Access Compliance Report

Public Rights-of-Way

Intersection ID: 17205	Main Street: LINDA_LN	Cross Street: WALKER_RD	Location: SW
ADA ID: 95BD4BC4749D	Ramp Type: ParaDiag	Initial Pass/Fail: Pass	Overall Compliance: No
		Severity Score: 4

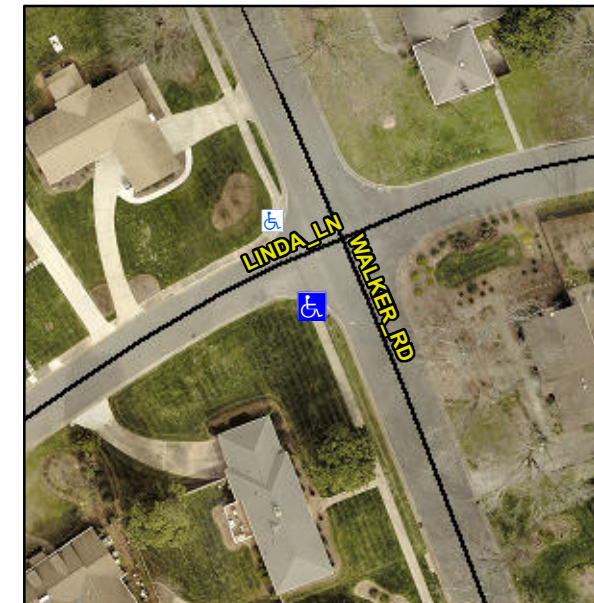
ASP LIP 0.5, RT RP < 5%

Not Found, R304.2.1, R305.2

Compliance	Description	Data	Compliance	Description	Data
N/A	Ramp Length LT (in)	58.0	N/A	Ramp Length RT (in)	63.0
Yes	Ramp Width LT (in)	49.0	Yes	Ramp Width RT (in)	49.0
Yes	Ramp Slope LT (%)	6.6	Yes	Ramp Slope RT (%)	4.2
Yes	Ramp XSlope LT (%)	0.2	Yes	Ramp XSlope RT (%)	2.0
No	Landing Length (in)	47.0	Yes	DWS Provided?	Yes
No	Landing Width (in)	41.0	Yes	DWS Contrast?	Yes
Yes	Landing Slope (%)	1.3	Yes	DWS Length (in)	24.0
Yes	Landing X Slope (%)	1.4	Yes	DWS Full Width?	Yes
N/A	Landing Curb? (Y/N)	No	No	DWS Offset (in)	4.0
N/A	Shared Landing?	No			
Yes	Gutter Ponding?	No	Yes	Gutter Slope (%)	3.2
Yes	Gutter Lip Ht (in)	0.0	Yes	Gutter X Slope (%)	1.7
N/A	Painted X Walk1?	No	N/A	Painted X Walk2?	No
	X Walk 1 Direction	To NE		X Walk 2 Direction	To NW
N/A	X Walk 1 Width (in)	N/A	N/A	X Walk 2 Width (in)	N/A
	X Walk 1 Slope (%)	3.0		X Walk 2 Slope (%)	1.9
	X Walk 1 X Slope (%)	0.9		X Walk 2 X Slope (%)	0.6
N/A	Ramp inside XWalk1?	N/A	N/A	Ramp inside XWalk2?	N/A

Remove & Replace Curb Ramp With Two New Directional Ramps or Equivalent.
